October 21, 2021

Subject: Review of Second Quarter 2021 Groundwater Management Zone (GMZ) Monitoring and System Performance Report (2Q 2021 Report)
Hamilton Sundstrand Corporation (HSC) Plant 1/2 Facility
Southeast Rockford Groundwater Contamination Superfund Site, Rockford, Illinois
ILD981000417

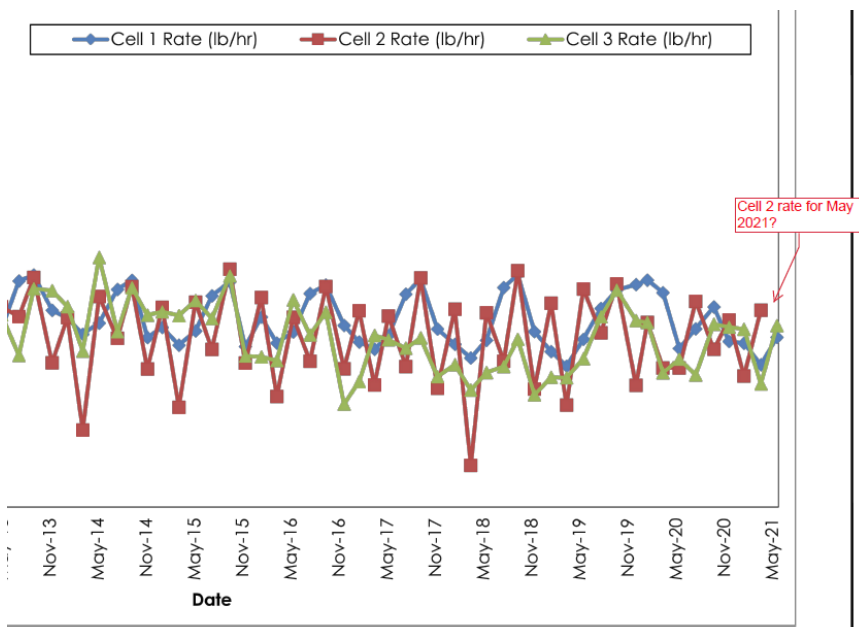
- Table 4.6. Cell 1 Column. End of Table.** Cell 1 appears to have been off from the period 3/26-5/26, but the cumulative mass removed increased. Please verify and correct as necessary.

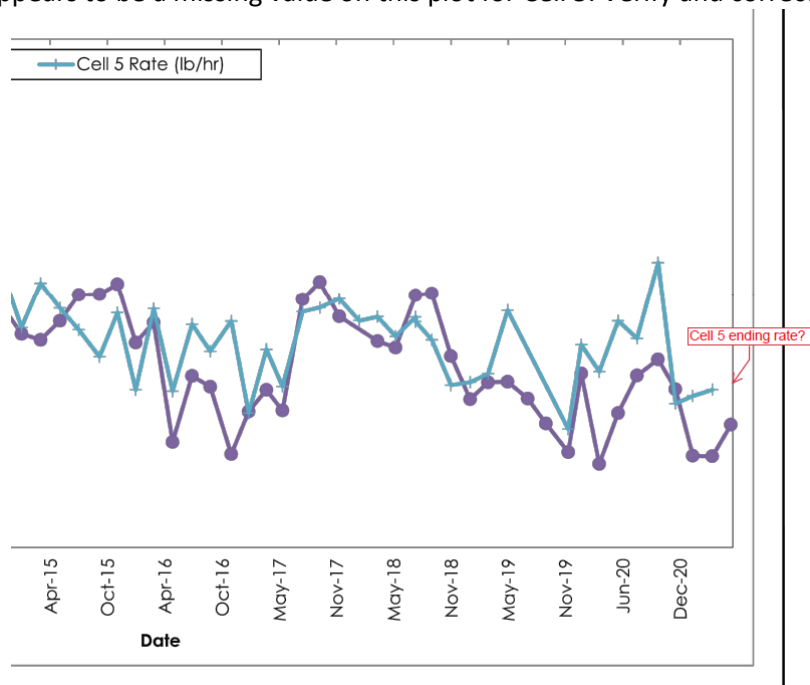
3. **Figure 4.** There are dashed potentiometric lines in the figure. Please add this symbol and definition (dashed where inferred/approximately located) to the legend.
4. **Figure 5.** The results box for PMW02 shows two rows for 24-Feb-21. Verify and correct as necessary.
